| 10 | Septic Upgrade for:                                                                                                                                                     |
| 9  | Block 8424, Lot 16                                                                                                                                                      |

Re: Sergey & Raisa Aminov  
Block 8424, Lot 16, 10 Appaloosa Drive  
Manalapan, NJ, CEC File No. 32629

Your draft letter addressing the addition of a septic tank to accommodate the 50% over sizing requirement for the ejector pump is satisfactory. However, you still need to address #1, the NJDEP inspection of the existing system and that it is not malfunctioning. ( inspection forms are on line) I have attached a copy of the Advisory on this issue again for your review and attached a note for the issues that are pending.

**Septic Tank Detail**  
1,500 Gal.

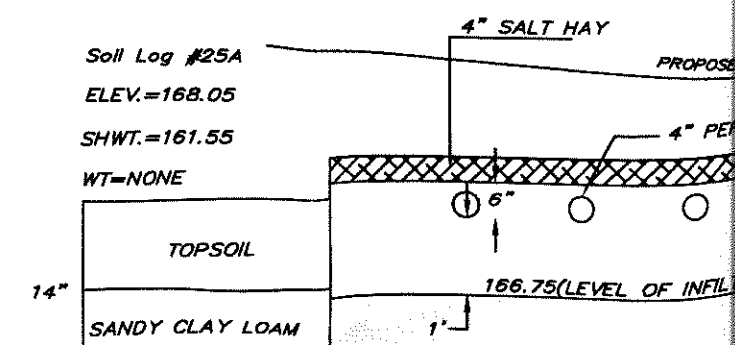
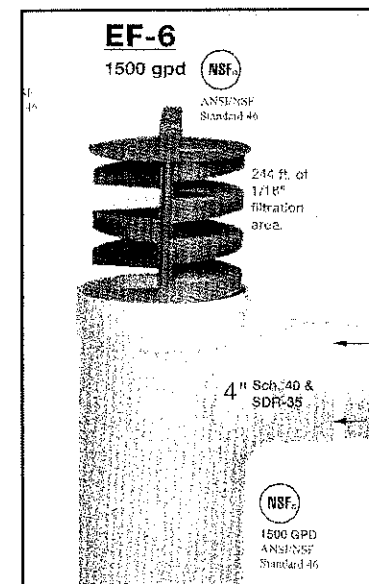
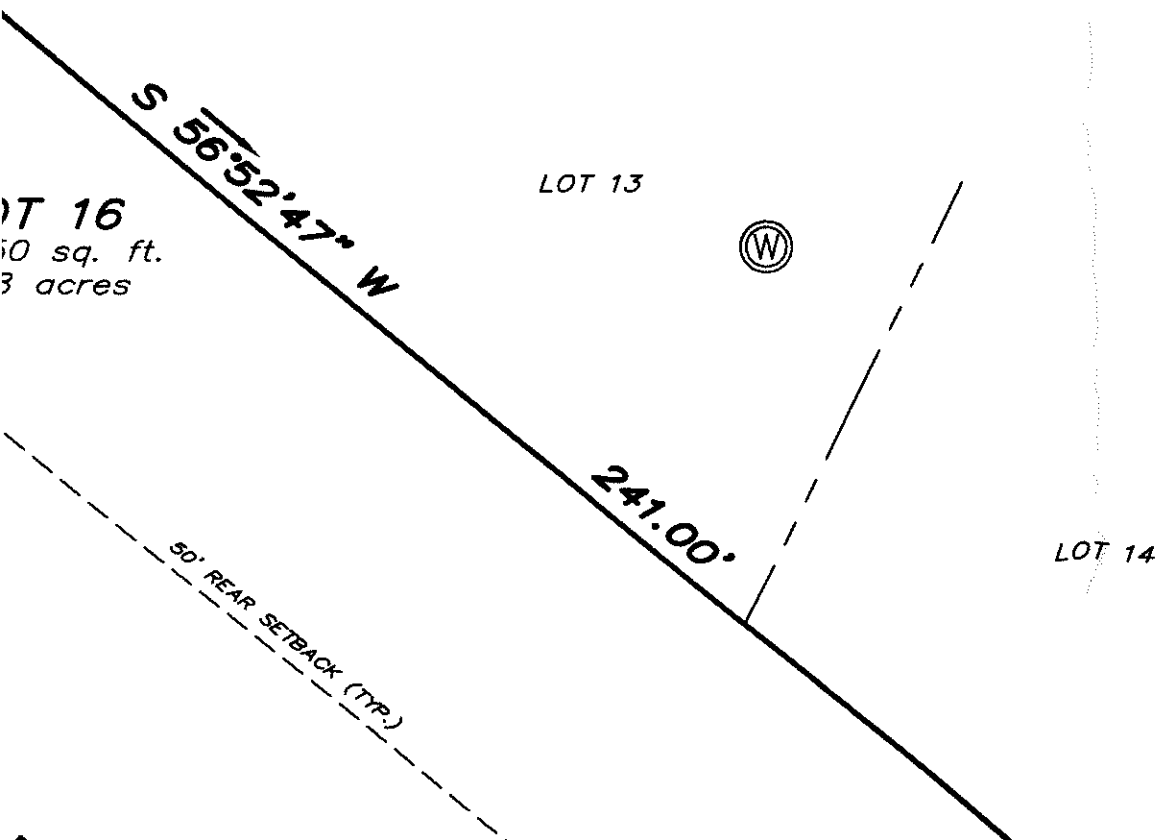
The plan calls for a 1,500 gallon tank in front of the existing 1,350 gallon tank. Over 100% increase.

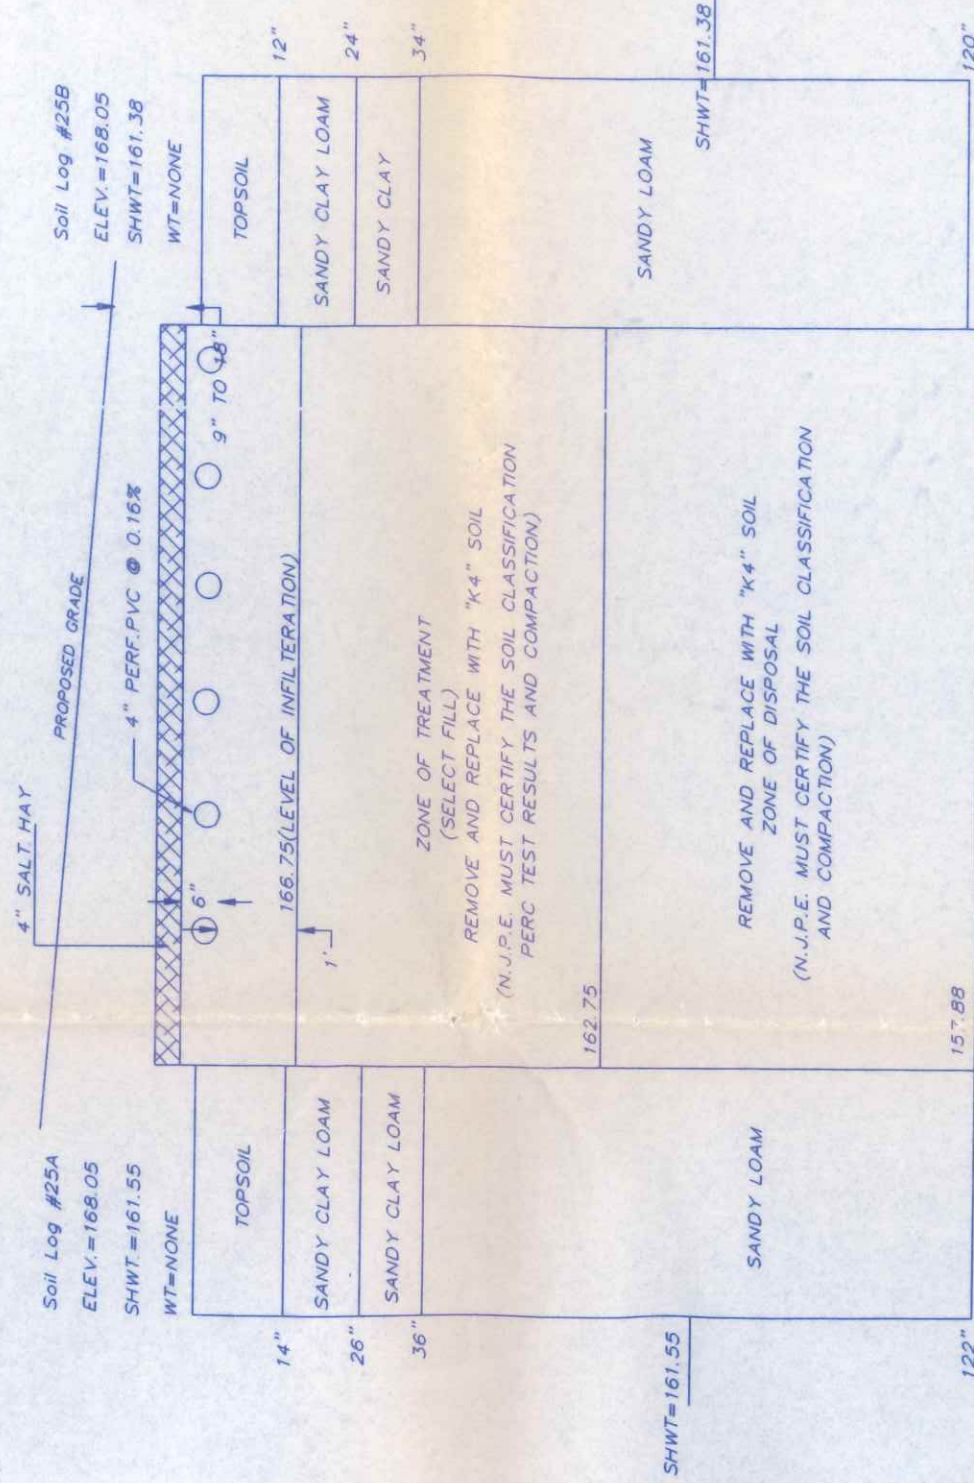
As per your review letter of June 4, 1999, we have revised the septic design for the lots listed below and offer the following comments:

- ☐ A revised application indicating 1350 gallons has been submitted.
- ☐ The distance from the septic field to stormwater pipe has been indicated on the plan.
- ☐ A note has been added to the plan indicating the prohibition of water softener being discharged into the septic system.
